**ADDENDUM NUMBER 5**

- 1.01 DATE: MAY 19, 2021**
- 1.02 PROJECT: RENOVATIONS TO BUCHANAN HALL PHASE II**
- 1.03 PROJECT NUMBER: DCM NO. 2021305**
- 1.04 OWNER: ALABAMA A&M UNIVERSITY**
- 1.05 ARCHITECT: NOLA | VAN PEURSEM ARCHITECTS, PC**

SHEET NUMBER  
**M-2.4**  
OF  
19

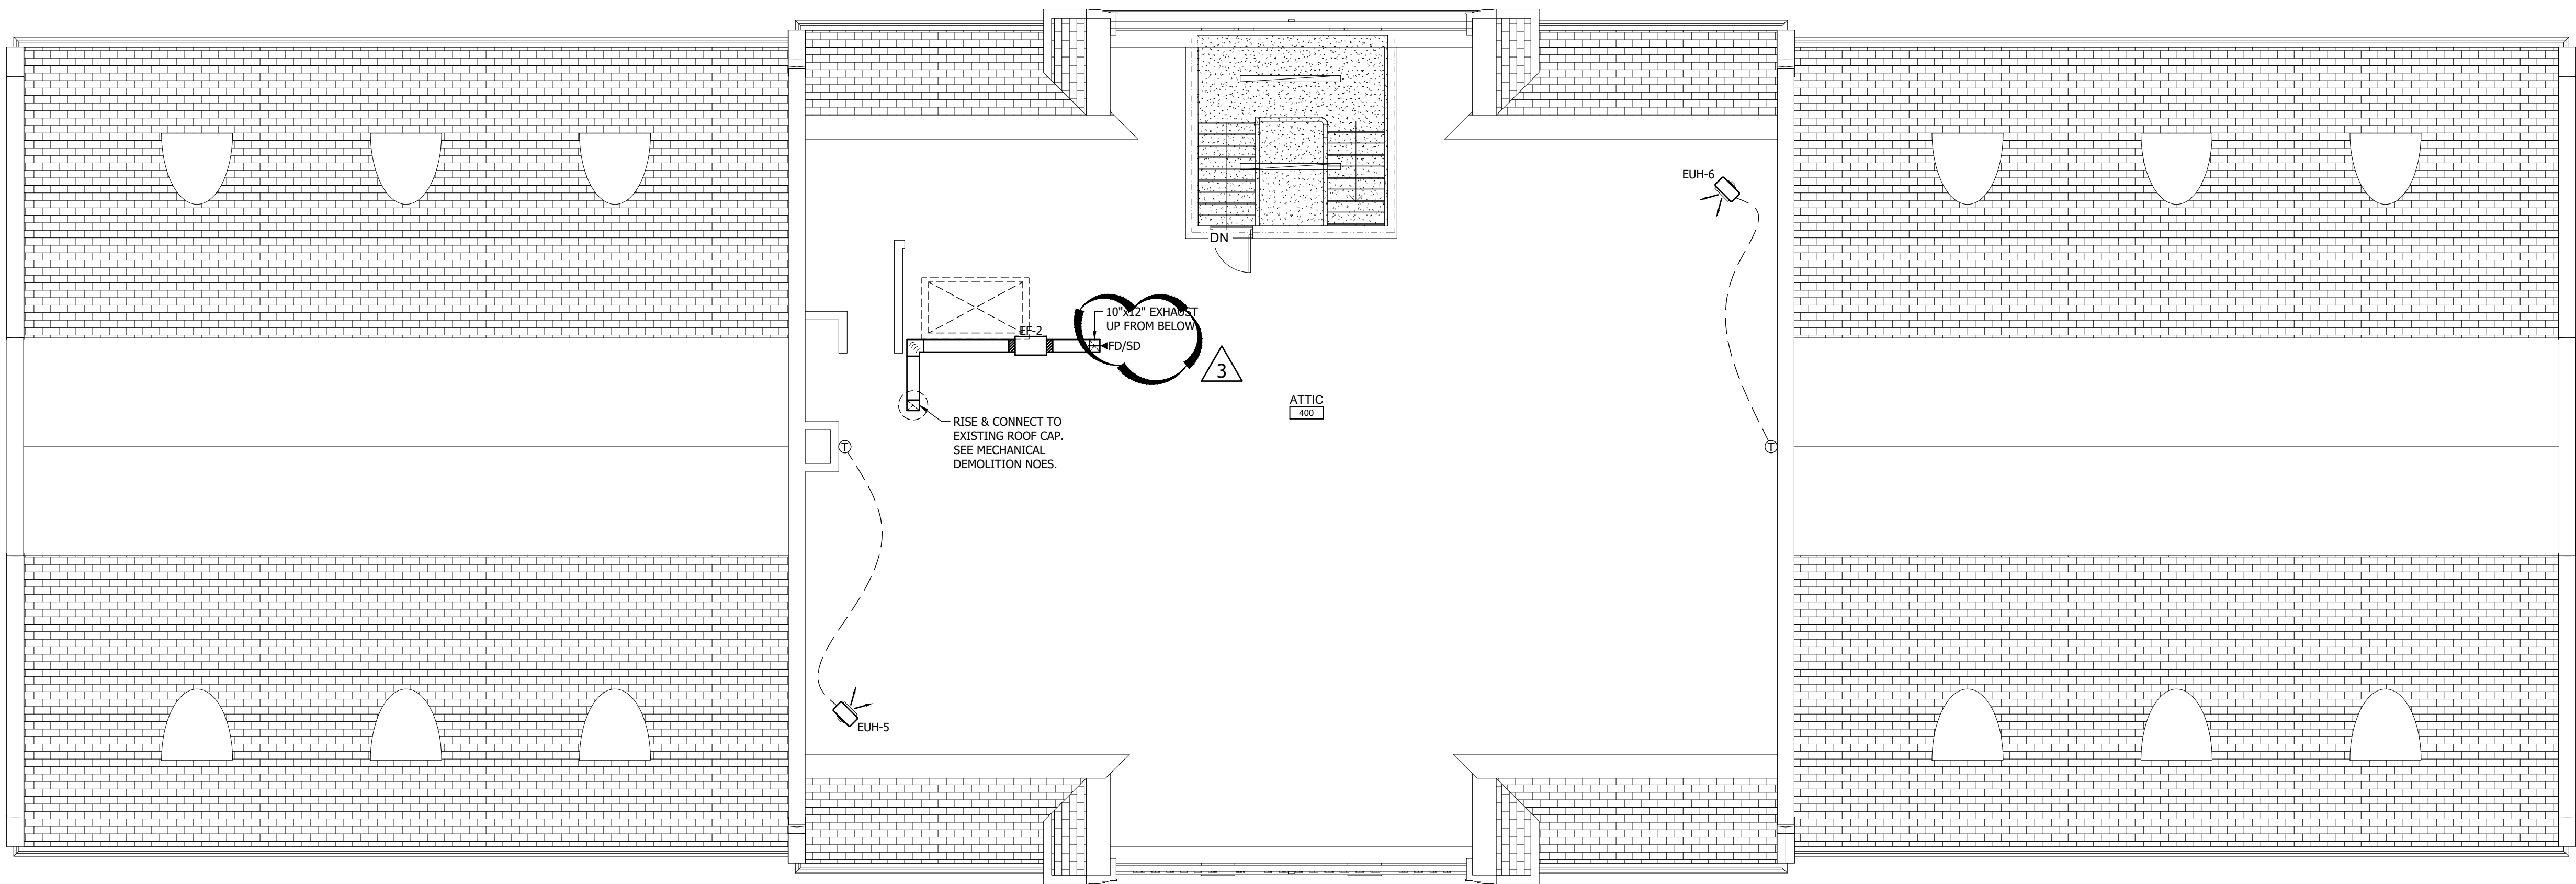
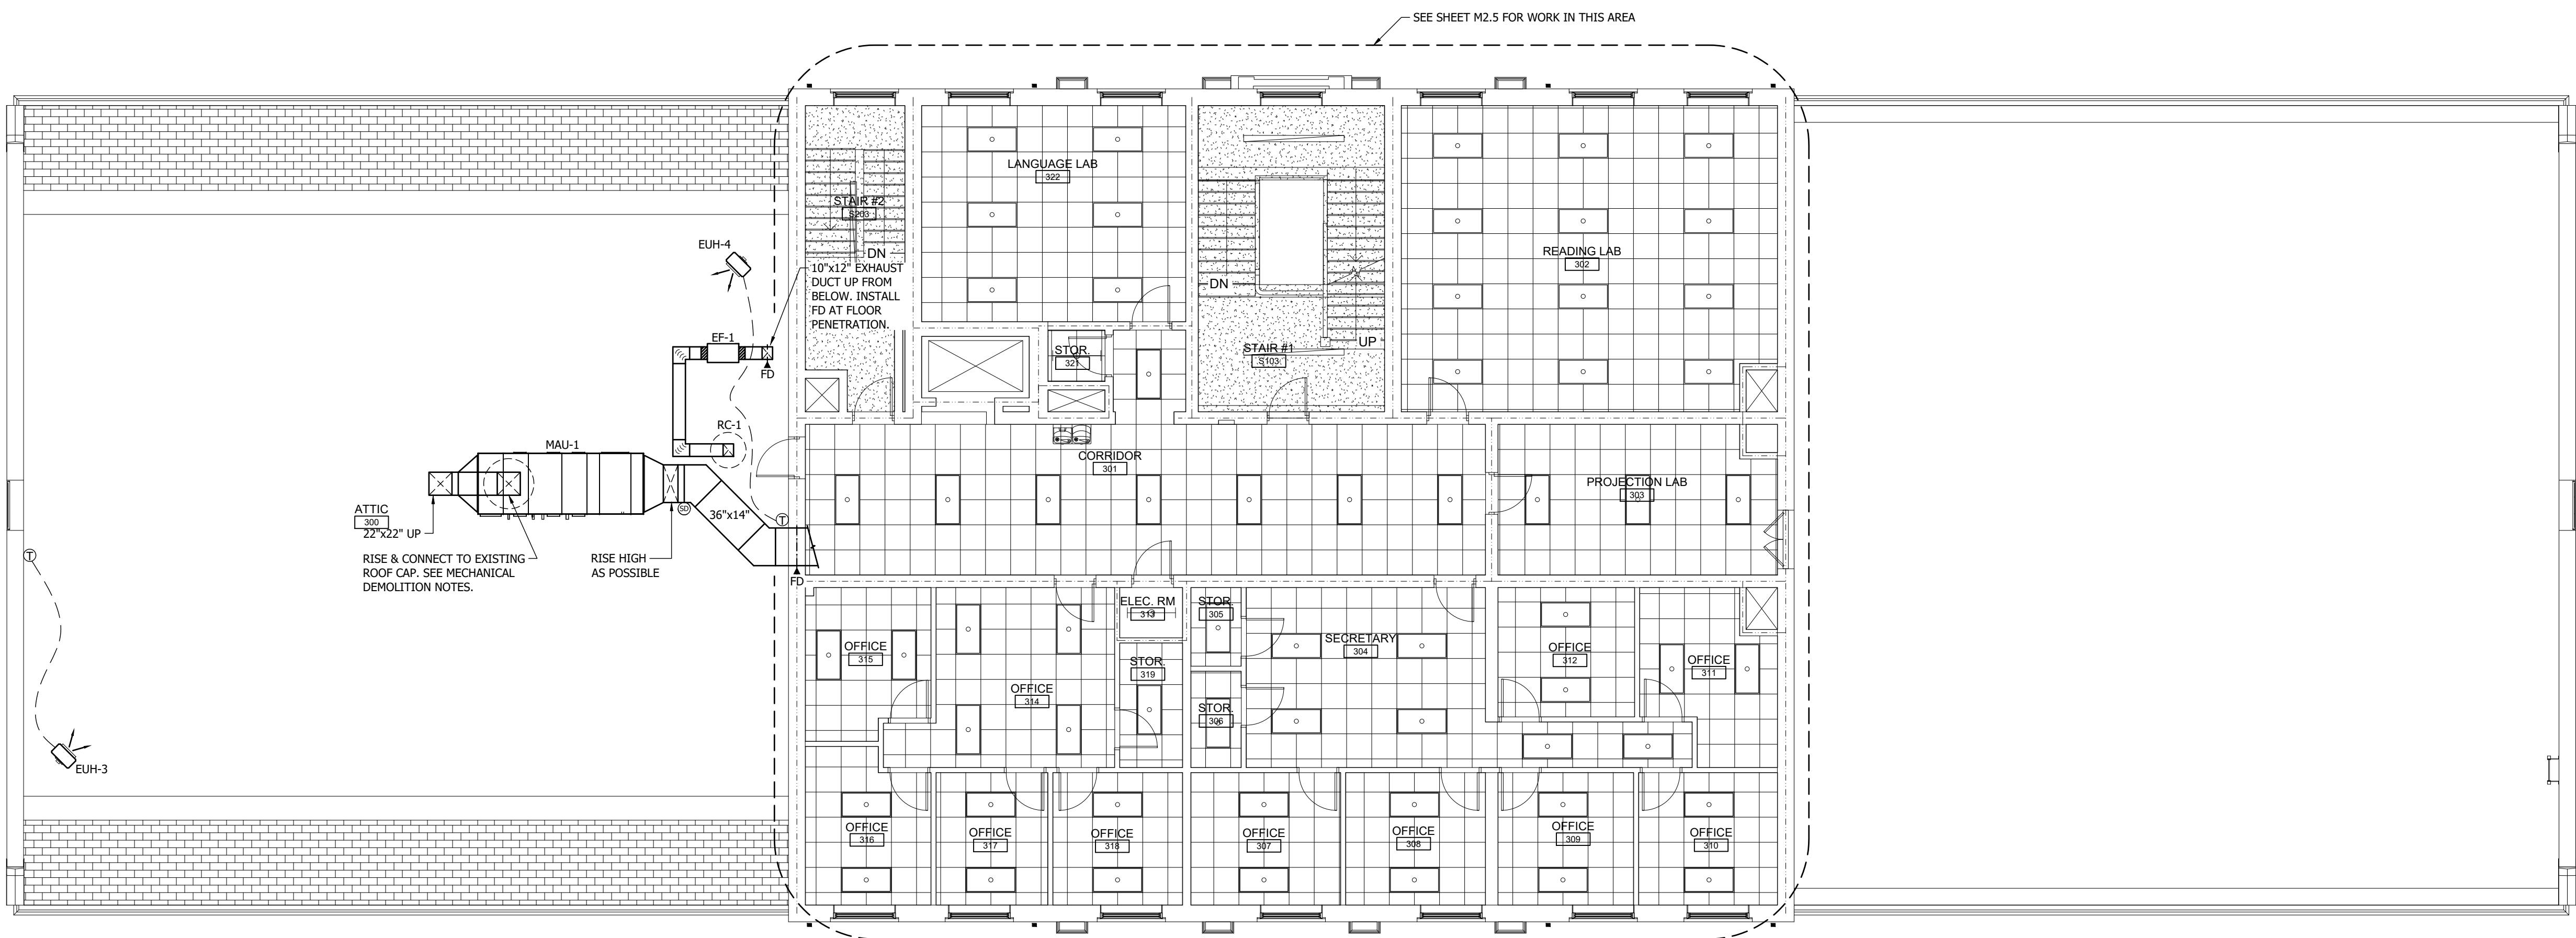
**4.04 SHEETS M-2.1, M-2.3, M-2.4, AND M-2.5:**

- A. Replace these sheets in their entirety. Revisions include:
  - 1. Changed fire dampers to fire/smoke dampers at locations identified on plans.

FIELD LINE DETAIL  
NOT TO SCALE

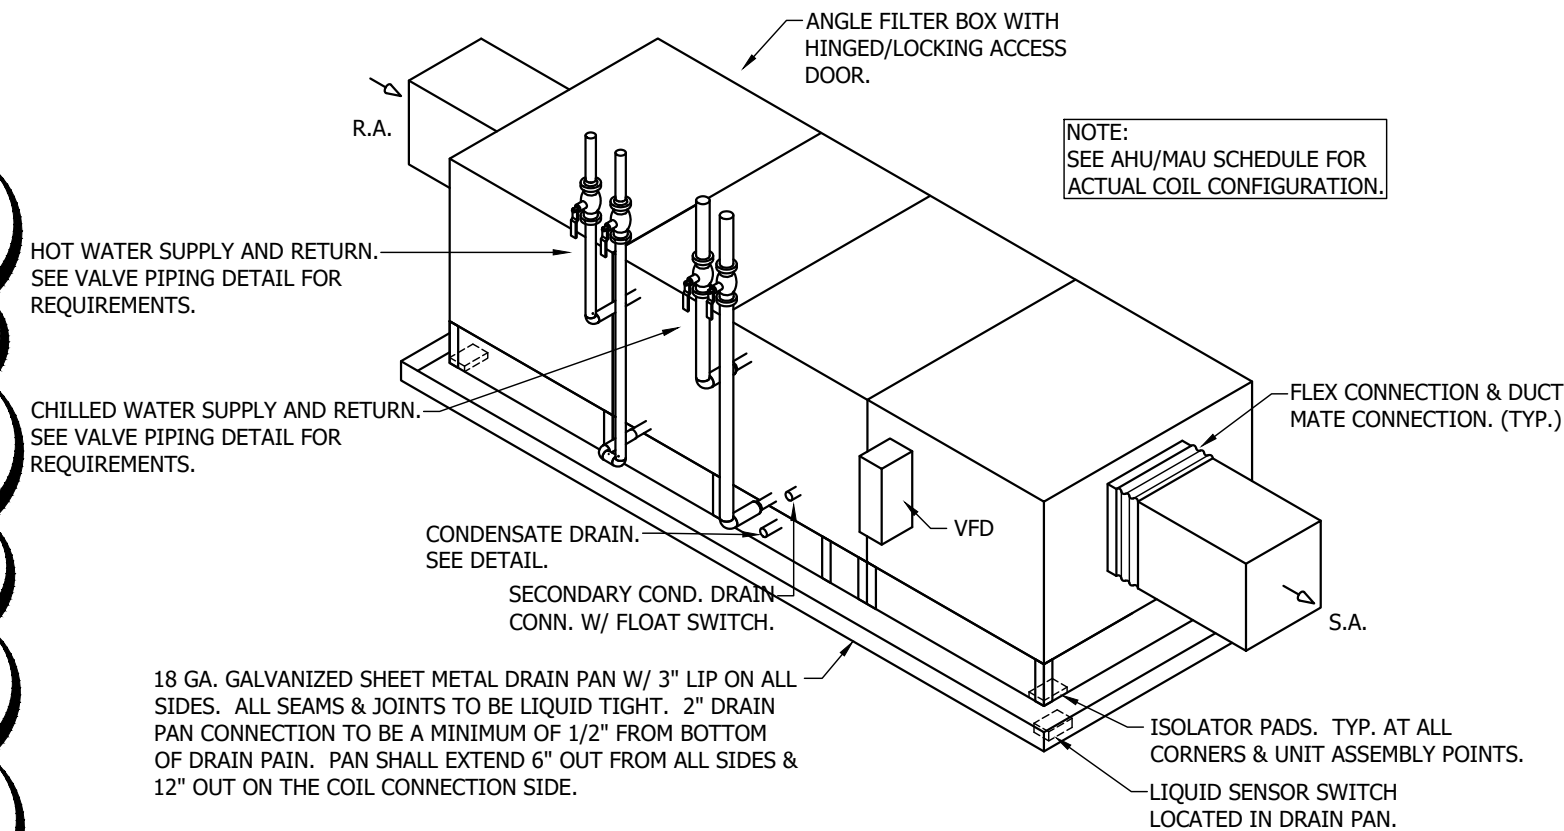
**4.06 SHEET M-6.1 – MECHANICAL DETAILS:**

- A. Replace this sheet in its entirety. Revisions include:
  - 1. Added Field Line Detail.

SHEET NUMBER  
**E-3.0**  
OF

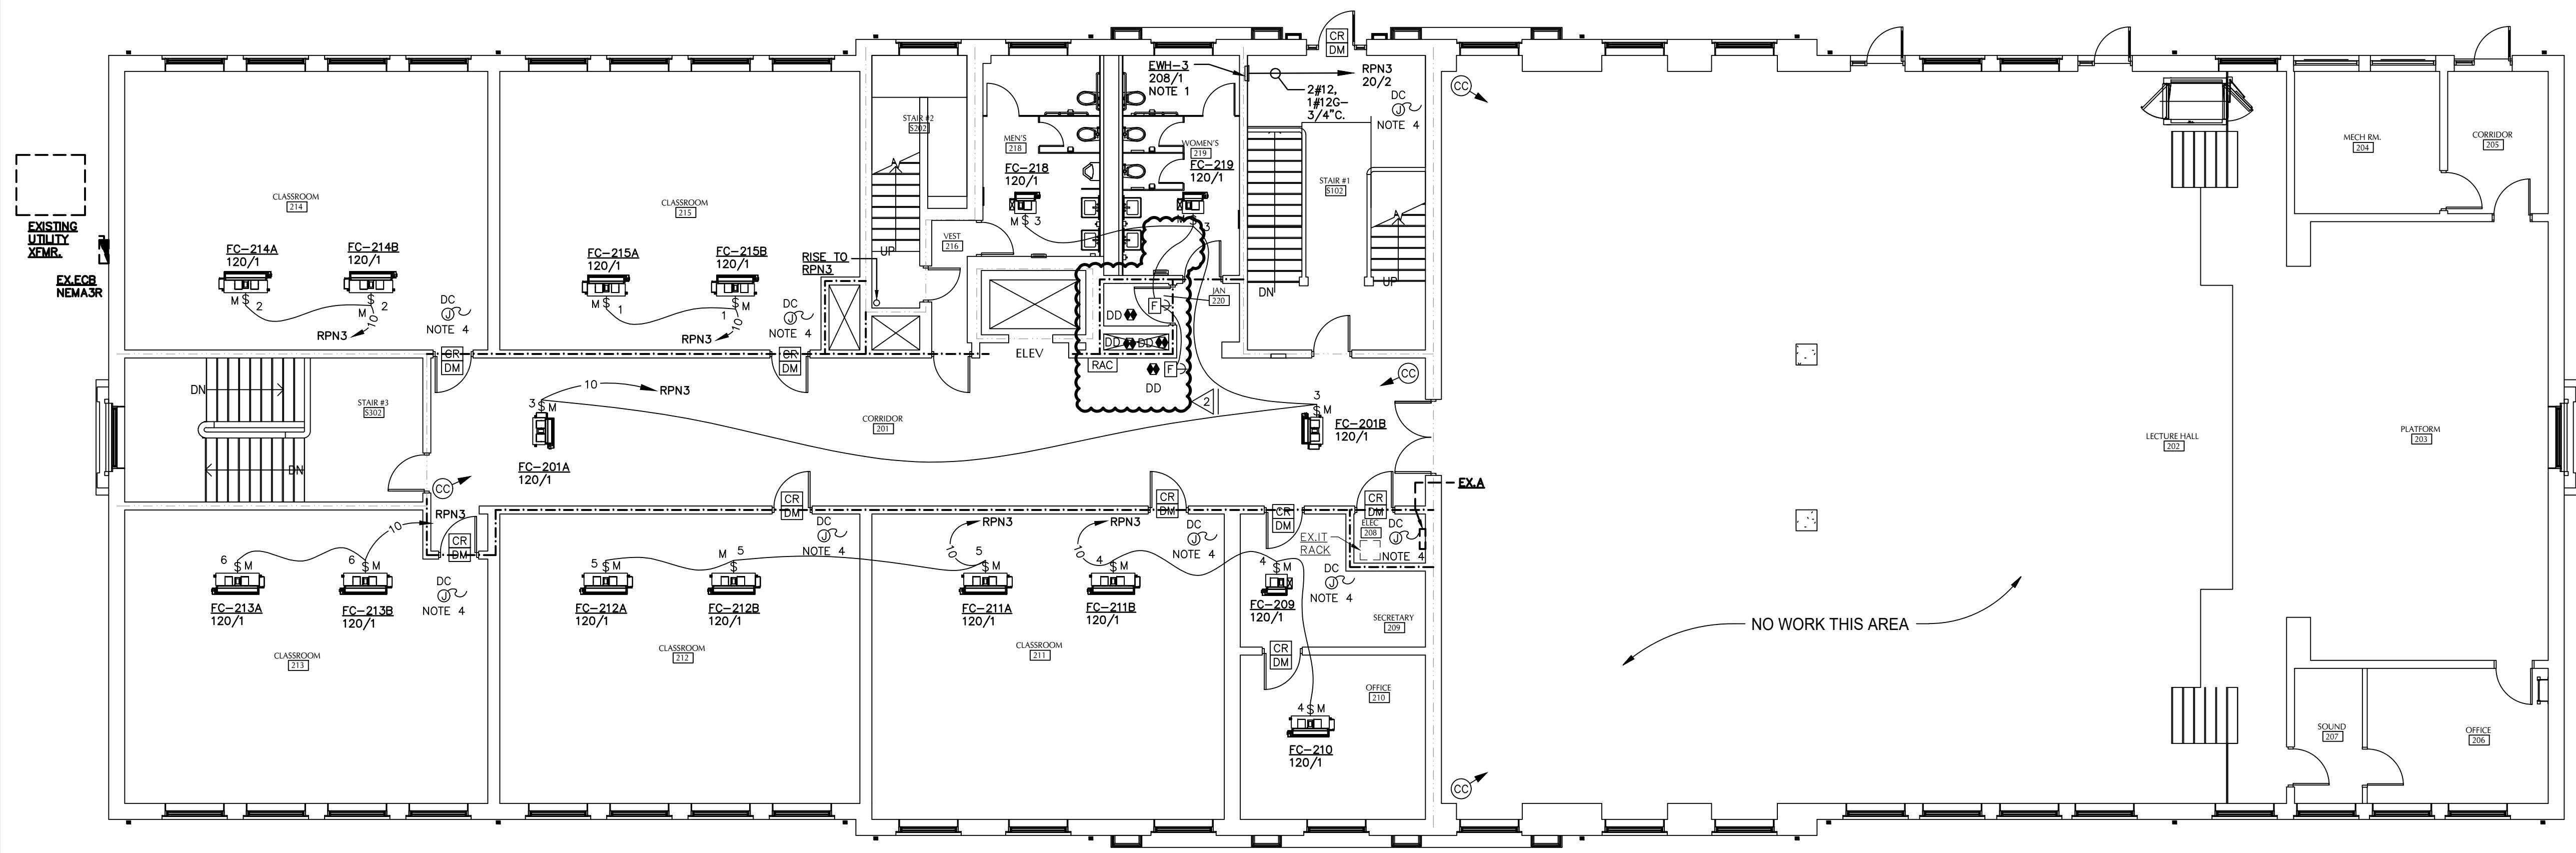
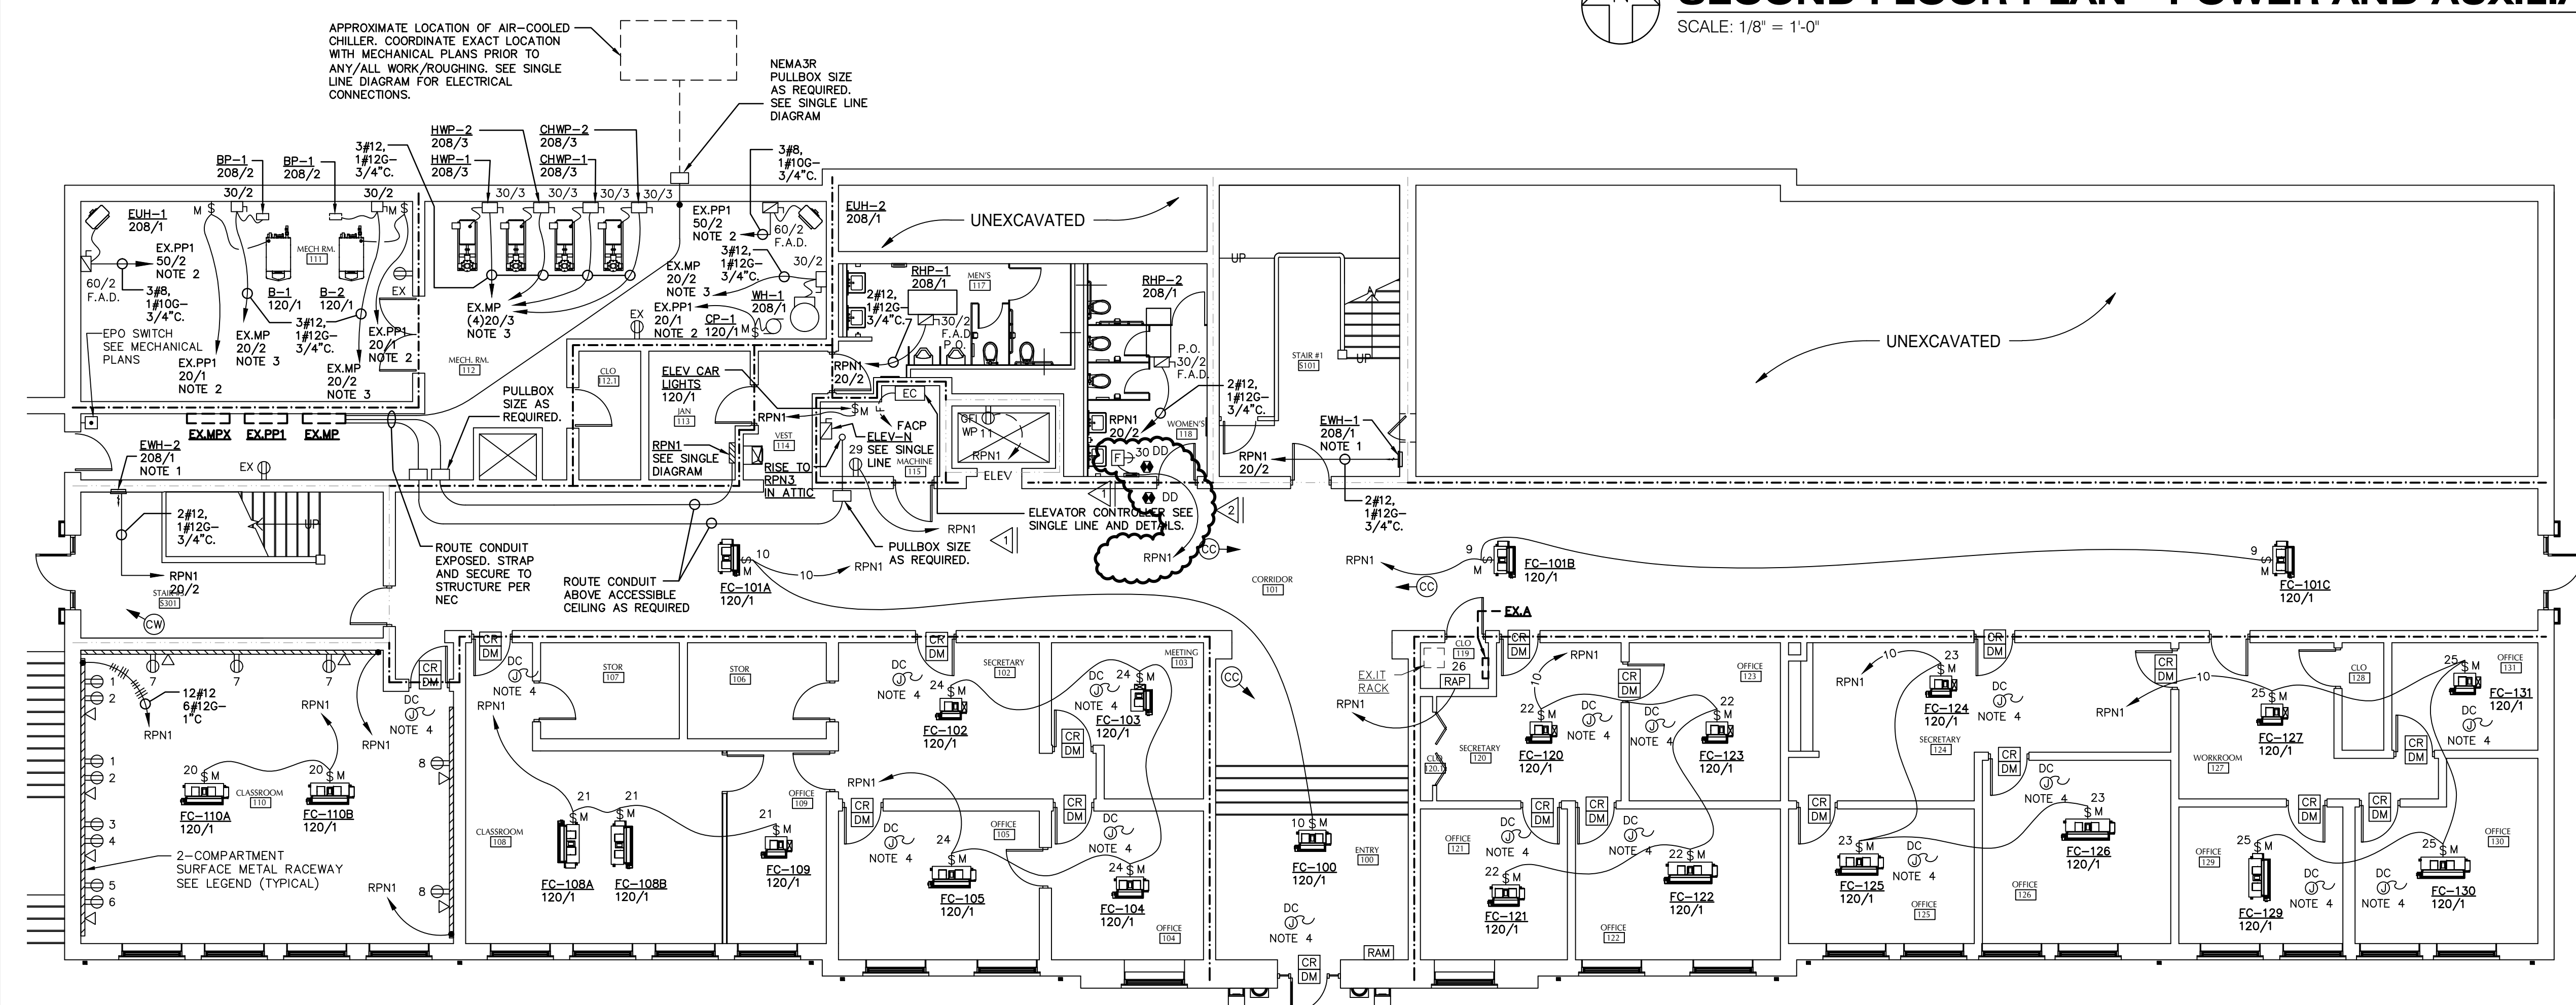
**4.08 SHEET E-3.0 - ELECTRICAL FIRST AND SECOND PLAN - POWER AND AUXILIARY:**

- A. Replace this sheet in its entirety. Revisions include:
  - 1. Added motorized damper and duct detector in locations indicated.
